Item 4.**Development Application: 65 Cowper Wharf Roadway, Woolloomooloo**

File No.: D/2018/335

Summary Recommendation:	This proposal is recommended for refusal.

Figure 5: Excerpt of the proposed roof plan

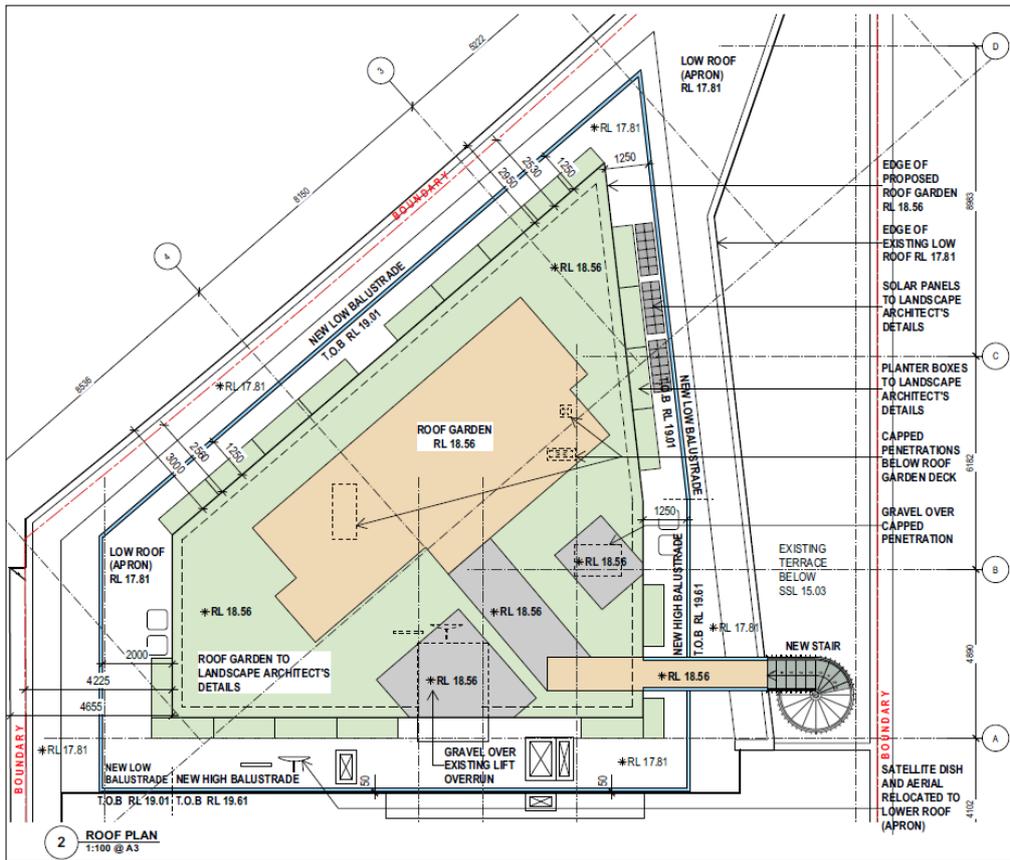
22. The proposal includes works on the existing roof including a roof garden and deck area with associated glass balustrades. The proposal has a maximum height of 17.04m, measured to the top of the balustrade on the southern and eastern sides of the roof.
23. The maximum height in metres, prescribed under Clause 4.3 of Sydney LEP 2012 is 15m. This results in a 13.6% (2.04m) exceedance of the control.
24. The applicant is relying on the provisions of Clause 4.6 of the Sydney LEP 2012 to seek an exception to the height in metres standard.
25. In order to demonstrate whether strict numeric compliance is unreasonable and unnecessary in this instance, the proposed exception to the height of buildings development standard has been considered against the objectives and provisions of Clause 4.6 in the table below.

Figure 11: Existing view from the fifth floor elevated communal pool area including current view of the Sydney Harbour Bridge, taken from the submitted view analysis.

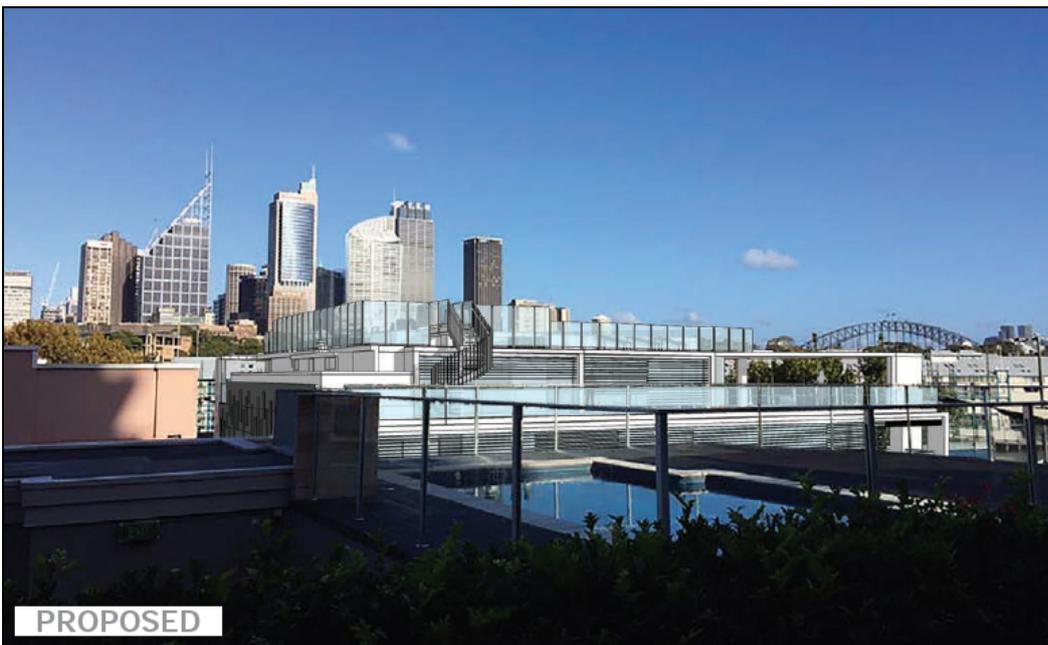
30. Figure 11 indicates that existing views to the Sydney Harbour Bridge are partial from the deck of a communal pool on the neighbouring site to the east. Figure 12 indicates that views will be obstructed by the proposal from this location.

32. Figure 11 also indicates that part of the existing view to the Sydney skyline to the west will be lost as a result of the development. The level of existing views to the city skyline is moderately impacted by the development proposed. Partial views of buildings can still be seen above the proposed balustrading and stair enclosure on the roof.

Figure 12: View from the fifth floor elevated communal pool area including the proposed view of the Sydney Harbour Bridge, taken from the submitted view analysis.

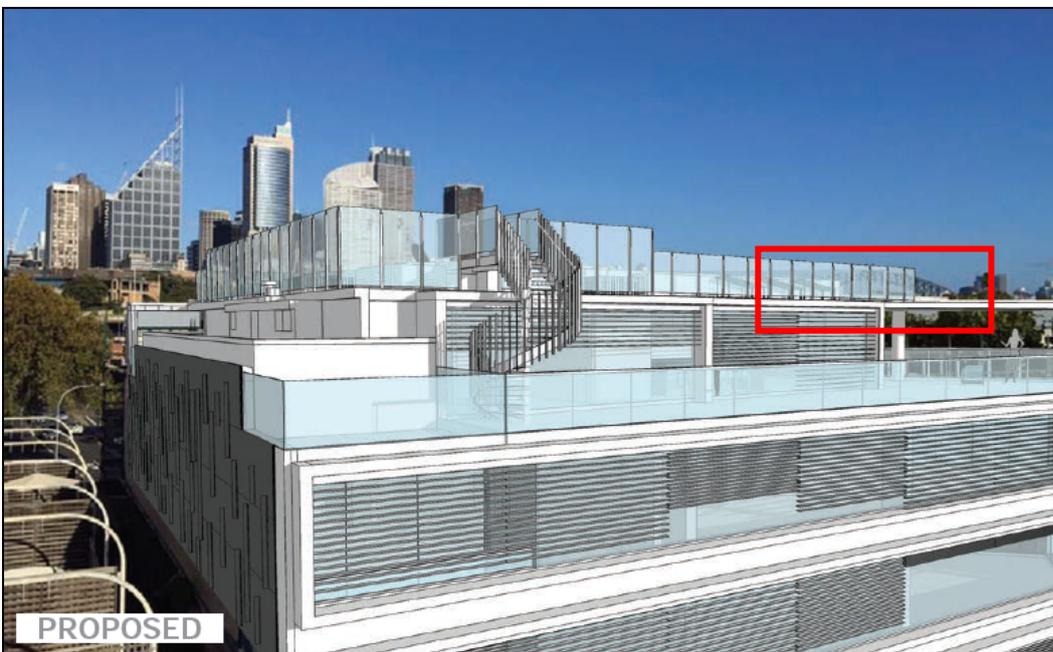
31. The reduction of these views is considered severe, due to the both the volume of the obstruction on a horizontal plane as well as the iconic nature of the object being viewed.

35. In accordance with the planning principle of the Land and Environment Court, the impact that the proposal will have on views from the surrounding properties is considered unacceptable, with a view of the Sydney Harbour Bridge being viewed as severe from the location indicated in Figure 12.

39. The conditions of other sections of Council have been included in the proposed conditions.
40. The application was discussed with the Urban Design specialists, Building Services Unit, Surveyors, and Landscape specialists.
41. Council's Urban Design specialists indicated that the information submitted with this application specifically showed that both iconic views of the Sydney Harbour Bridge and land-based views of the city skyline would be lost as a result of the development, referring to Figure 12.
